**Technical Service Bulletin**

**Subject:** TSB-Braun Pro 4000 Product Update

**Product(s) Referenced:** Braun PRO 4000 (04000-200, 04000-300, 04000-400, 04000-MC,  
04000-MC1, 04000-500, 04000-600, 04000-900)

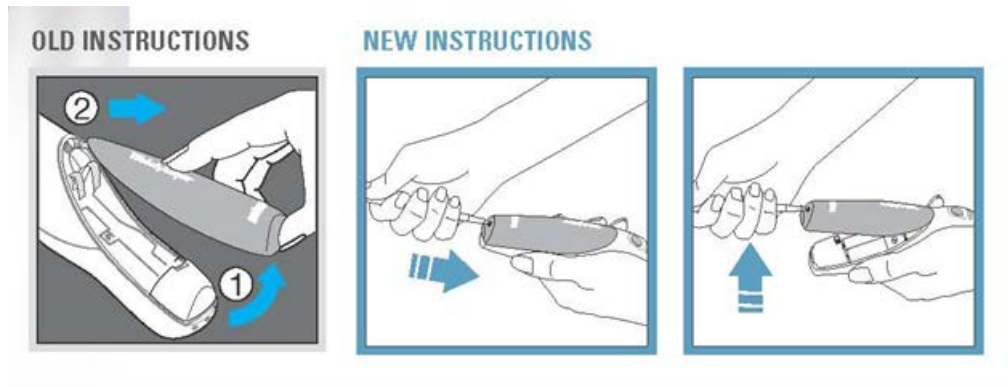
1. Probe Cover Sensing Pin has a wider diameter providing increase part strength
